2. COA-081794-2020

5 West Clay Street

Commission of Architectural Review

STAFF REPORT

Figure 2. Rear alley, looking west.

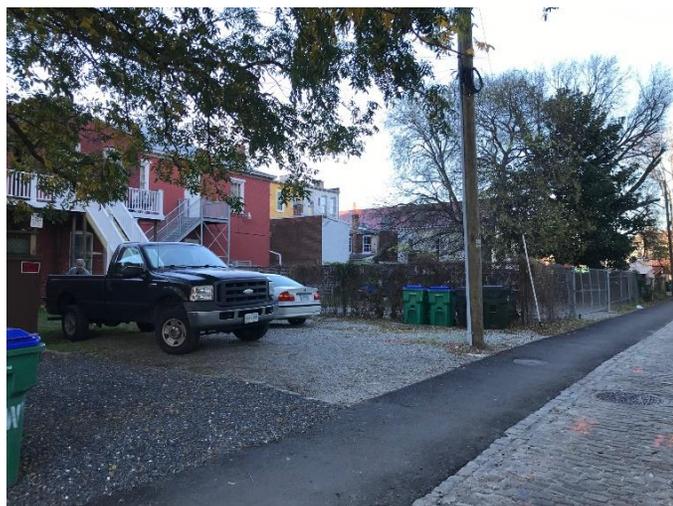
The proposed carport is located at the rear of the property and faces the alley, respecting the siting and orientation of other adjacent outbuildings. The dark color being proposed is neutral, and is compatible with the other colors found within district.
